Glessner House

Exterior & courtyard audit

Photographic completion study • 1904-07-01 target • reviewed 2026-10-08

Current model — prairie

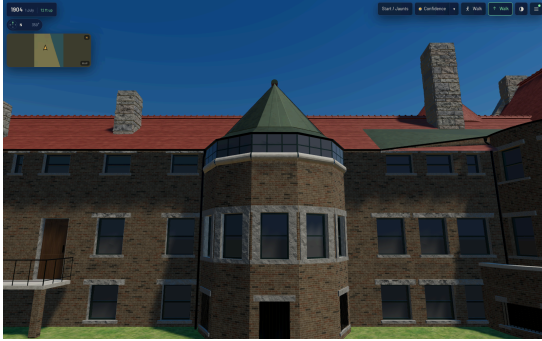
Finding: Close-ups show noisy faceted stone and highly uniform joint treatment; at street distance the texture overwhelms coherent masonry. Shaded walls lose the intended rock-face relief.

Finding: Window panes use repetitive dark fields and simplified frame profiles. The front grouping is already present; this audit does not establish a wrong opening count.

Finding: Windows appear as nearly identical dark blue-gray panels with repeating diagonal shading; historical images show varied shades and surface response.

Proposed work: Refine block coursing, face projection, dressed margins, joints and corner/opening returns using Wellesley-granite evidence. Keep texture scale physical and separate stone variation from lighting.

Proposed work: Inventory every exterior opening by elevation; refine sash sections, meeting rails, recess depths, mullions, sills, drip edges and varied stone columns/capitals. Verify central upper front four-light group against HABS rather than guessing five.

Proposed work: Keep the owner-selected dark default. Add restrained reflection/roughness variation, appropriate shade positions and shallow backing visible from outside. Match documented special hall glass where supported; no furnished interiors.

Current model — courtyard

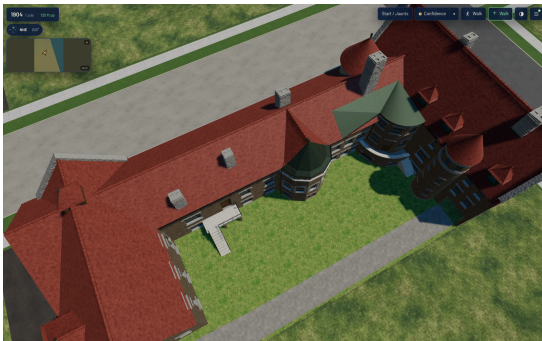
Finding: The audited scene opens the courtyard to surrounding grass; the continuous south enclosure is absent. Museum documentation attests a common-brick wall with vines since 1887.

Finding: The current courtyard reads dark brown with bright uniform trim. HABS identifies light pink common brick and Joliet limestone, distinct from street granite.

Finding: The bow entrance currently has simple white stacked steps. HABS photograph and section show shaped descending masonry beside the steps.

Proposed work: Build the documented enclosure, coping and returns; reconcile its height and shared relationship with 1808 from plans/sections. Join the west gate, stable and house without duplicate faces or gaps. Exact hidden construction remains inferred.

Proposed work: Calibrate brick dimensions, bond, mortar, roughness and pinkish color range using written evidence and documented surviving fabric. Give limestone lintels/sills their own finish; do not extract color from black-and-white photos.

Proposed work: Model the curved/stepped brick cheek, caps, treads, landing and door threshold from the section and photograph; resolve the exact curvature by matched view.
